UNITED STATES
NUCLEAR REGULATORY COMMISSION
REGION V

CONFIRMATORY ACTION LETTER

Subject: Return of Palo Verde I to Power Operations from Current Outage

ANPP/NRC MEETING TO DISCUSS
PVNGS AUXILIARY SPRAY CAPABILITY AND
THE STARTUP TESTING EVENT OF SEPTEMBER 12, 1985

DETAILED DESCRIPTION IN RESPONSE TO 440.6

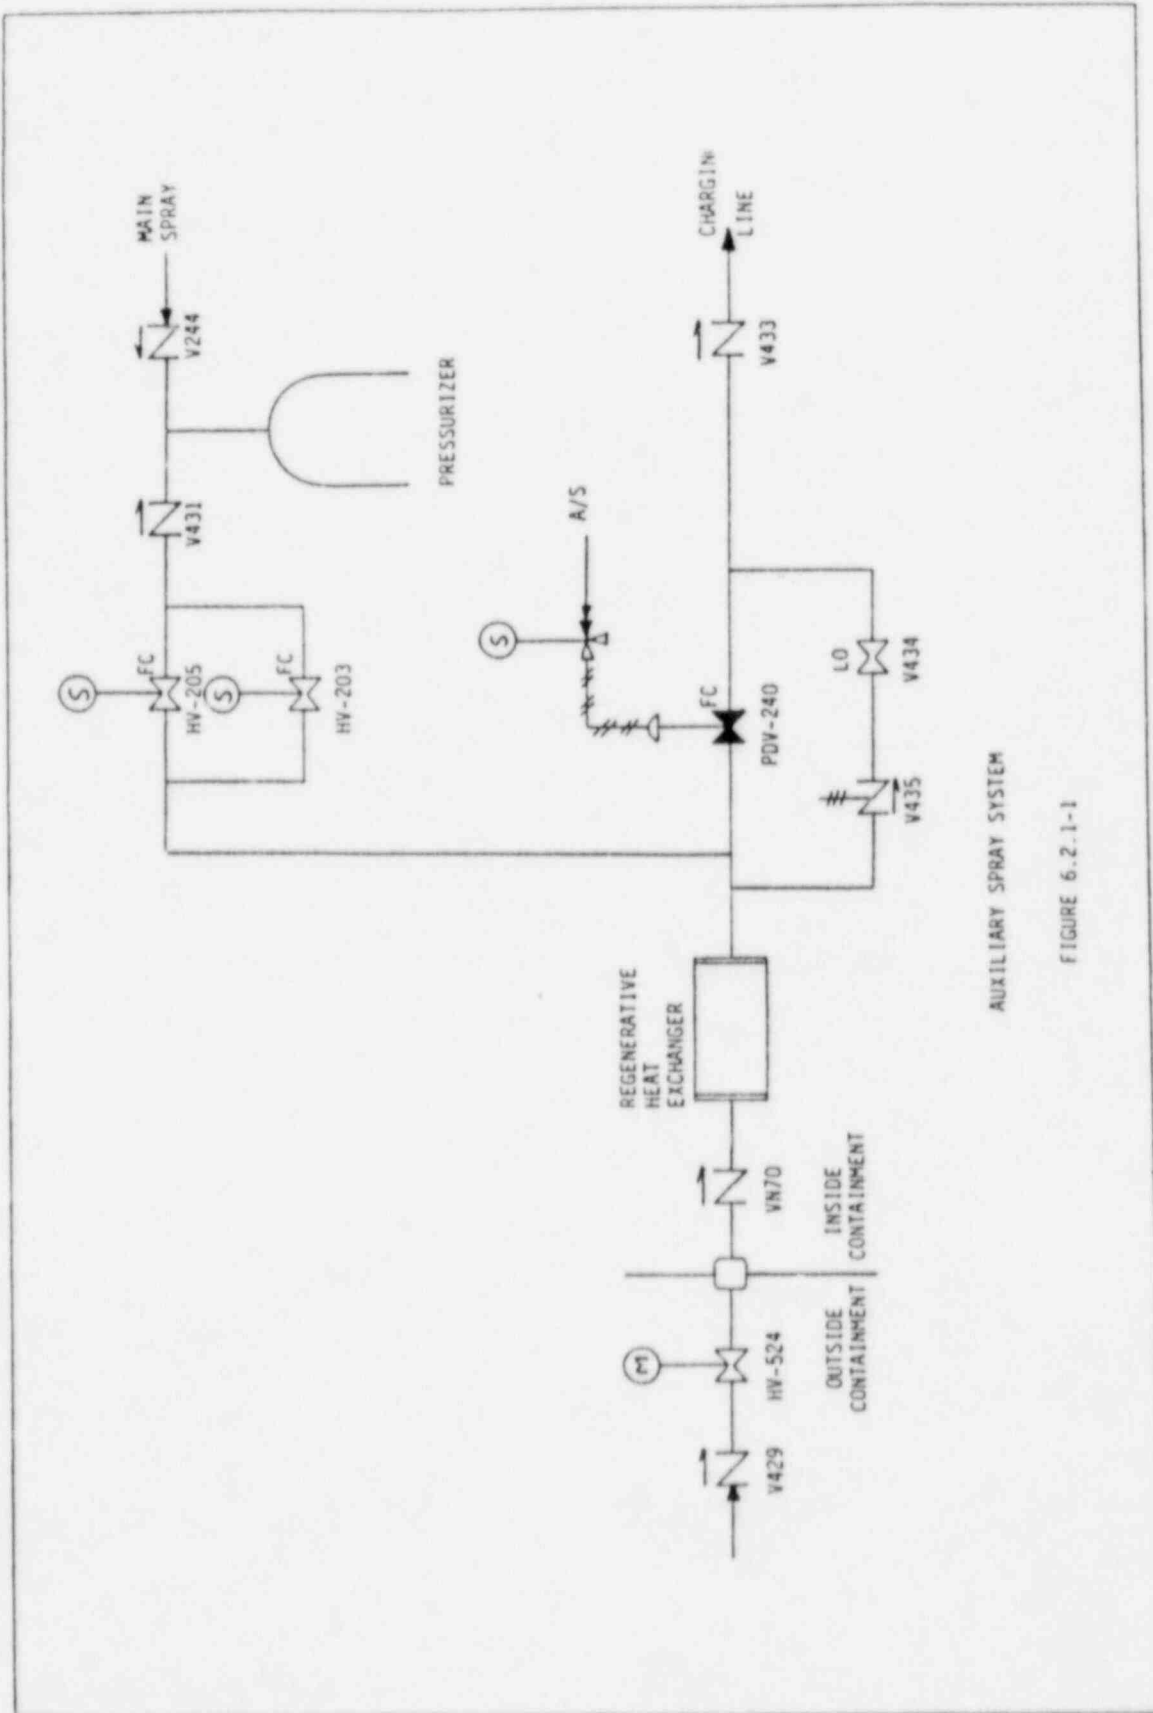
*why was some of water
not identified*
